## APPENDIX 1: CLAUSE-BY-CLAUSE BCA ASSESSMENT

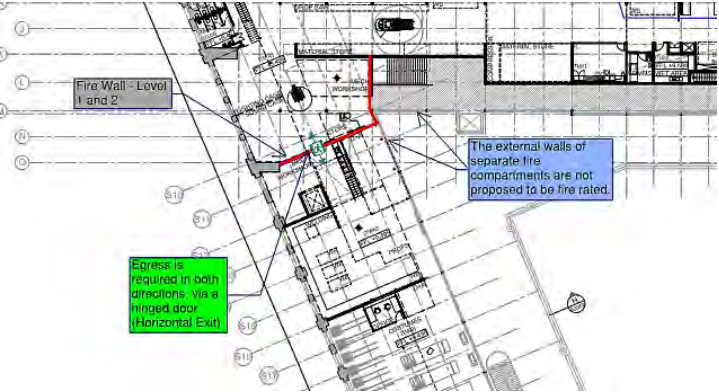
C2.8	<p>Separation of classifications in the same storey</p>	<p><b>Alternative Solution</b></p> <p>Fire separation is not proposed between the Class 6 and Class 9b parts. The deemed-to-satisfy provisions of the BCA require the FRL each building element in that storey must have the higher FRL prescribed in Specification C1.1 for that element for the classifications concerned, i.e. generally 3hr fire rating arising from the Class 6 classification, and 4 hours required for the storage and Workshop classification.</p> <p>Notwithstanding the above, we note that a fire engineered Alternative Solution is proposed for reduced FRLs having regard to the Class 6 part comprising a minor portion of the development, The Class 8 part remaining in place as an existing component of the building, however being primarily an ancillary part of the Theatre use, and the sprinkler protection throughout the development.</p> <p><b>Note:</b> Refer also the comments under Spec C1.1 with regards to Fire Engineered Strategy to rationalize a reduction in FRL's to 60min throughout in lieu of 120min and 240min.</p>

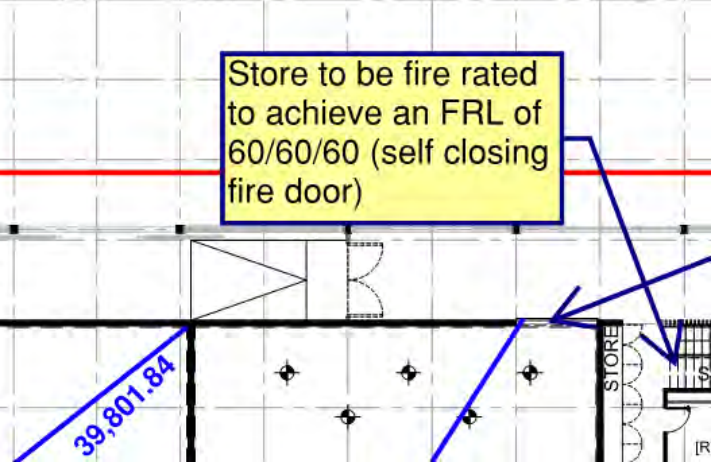
D2.7	Installations in exits and paths of travel	<p><b>Further Information Required</b></p> <p>(a) Access to service shafts and services other than to fire-</p>

<p>fighting or detection equipment, must not be provided from the fire-isolated stairways.</p> <p>(b) An opening to any chute or duct intended to convey hot products of combustion from a boiler, incinerator, fireplace or the like, must not be located in any part of a required exit or any corridor, hallway, lobby or the like leading to a required exit.</p> <p>(c) Gas or other fuel services must not be installed in a required exit.</p> <p>(d) Services or equipment comprising—</p> <ul style="list-style-type: none"><li>i. electricity meters, distribution boards or ducts; or</li><li>ii. central telecommunications distribution boards or equipment; or</li><li>iii. electrical motors or other motors serving equipment in the building,</li></ul> <p>may be installed in:</p> <ul style="list-style-type: none"><li>iv. a required exit, except for fire-isolated exits specified in (a); or</li><li>v. in any corridor, hallway, lobby or the like leading to a required exit,</li></ul> <p>if the services or equipment are enclosed by non-combustible construction or a fire-protective covering with doorways or openings suitably sealed against smoke spreading from the enclosure.</p> <p>(e) Electrical wiring may be installed in a fire-isolated exit if the wiring is associated with a lighting, detection, or pressurisation system serving the exit; or a security, surveillance or management system serving the exit; or the monitoring of hydrant or sprinkler isolating valves.</p> <p>Architect to note the above and specify construction accordingly. Particular attention will need to be paid to the electrical and communications equipment installed in the building.</p>
